NL-13-0997

Vogtle Electric Generating Plant
Pilot 10 CFR 50.69 License Amendment Request
Response to Request for Additional Information

**Vogtle Electric Generating Plant
Pilot 10 CFR 50.69 License Amendment Request
Response to Request for Additional Information**

**Response to Request for Additional Information
Regarding Pilot 10 CFR 50.69 License Amendment Request**

Figure 2.1-1 Initiating Event Update Tasks for the current VEGP PRA Model

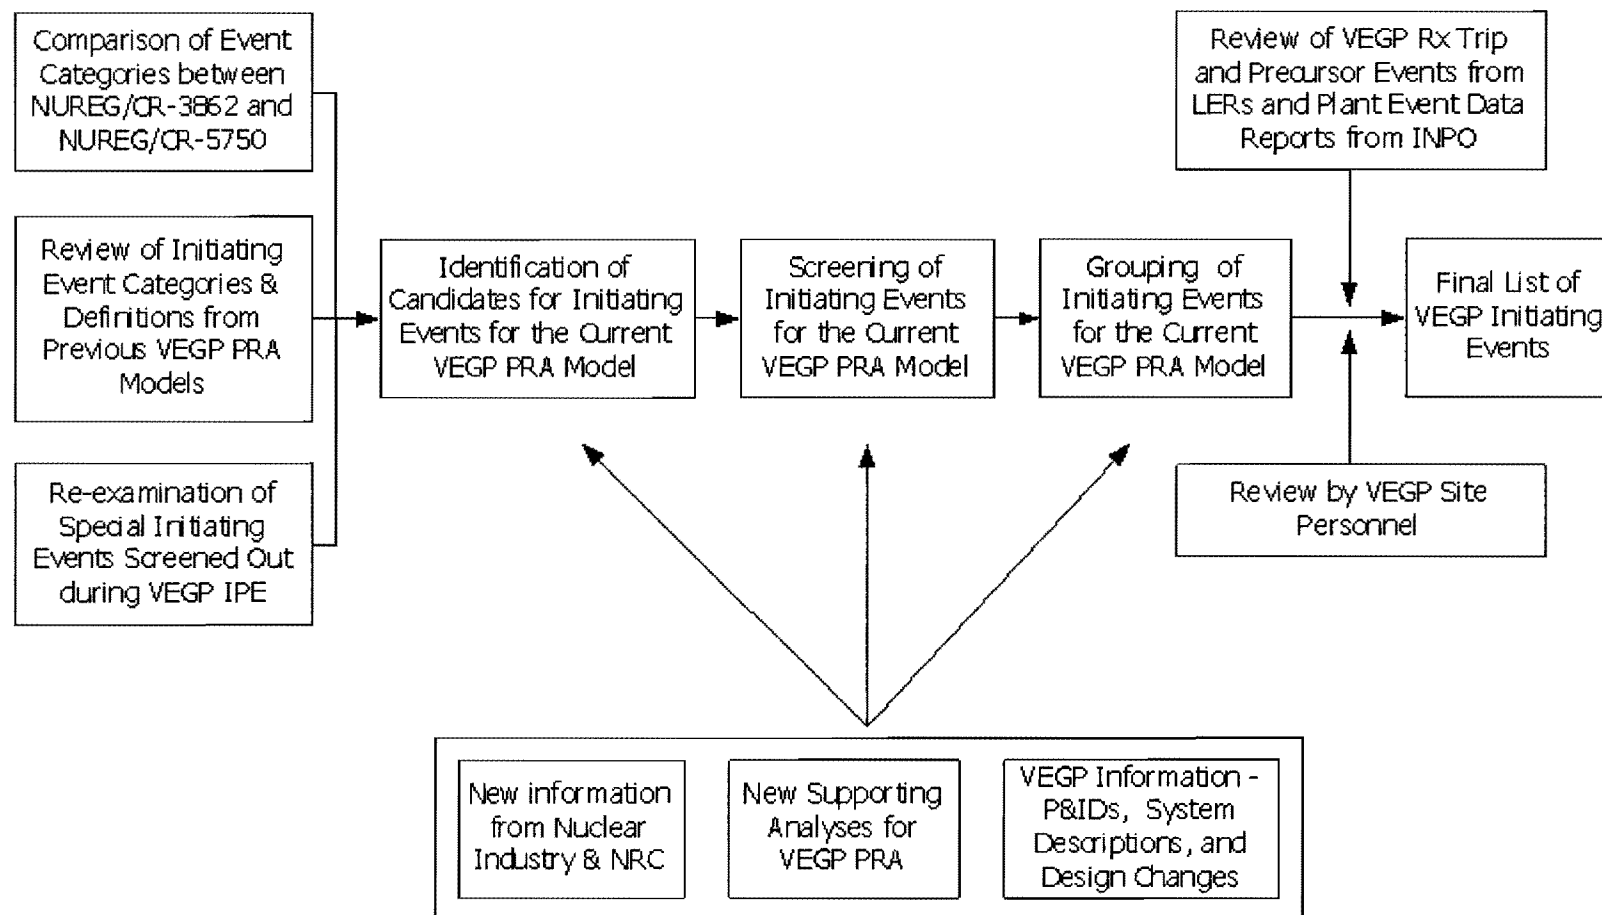
F&O IE-A4-01 appears to refer to the requirements in IE-A5, not IE-A4. The F&O states that simply crediting an evaluation performed for the Individual Plant Examination (IPE) is not sufficient to demonstrate a “structured approach.” Instead, the IPE evaluation should be reviewed and evaluated to determine whether it complies with ASME RA-Sc-2009. The resolution to this F&O states that an evaluation was performed during the Vogtle IPE using a “block diagram” but does not describe the methodology or whether it includes support systems and accounts for common cause failures as called for by ASME RA-Sc-2009. Please describe the structured approach that was used and an explanation of how it was reviewed and found to have met the aforementioned requirements.

In updating to the current VEGP internal event PRA model (that was peer reviewed in May 2009), a systematic identification of initiating events was performed again. The following Figure 2.1.1, “Initiating Event Update Tasks for the current VEGP PRA Model” (“block diagram”), summarizes a structured approach used to identify internal initiating events for the current VEGP internal events PRA model.

The Initiating Events from the previous versions of the VEGP internal events PRA models including VEGP IPE were compared with the generic list of initiating events from the recent references, NUREG/CR-3862, and NUREG/CR-5750 in order to develop a revised initial list of Initiating Events. Also, a review of failure effects of all supporting systems was performed again in order to identify a list of special initiating events. During the review of supporting system failures, an added focus was given to re-examination of the supporting system failures, which were screened out in the IPE. Any event that causes an automatic reactor trip was considered as an initiating event. In addition, any event which requires a manual reactor trip within 8 hours was also considered as an initiating event. The 8 hour criteria comes from the average time for controlled plant shutdown. As a result of re-examination, loss of Class 1E 4.16 KV bus A and Loss of Class 1E 4.16KV Bus B were added to the current VEGP internal event PRA as new special initiating events.

Before finalizing the initiating events groups, VEGP plant specific events that had occurred during the period from 1998 to 2008 were reviewed to determine if there were reactor trip events or precursor events that could result in any unique initiating events that might not have been identified previously. The review did not find any additional unique initiating events.
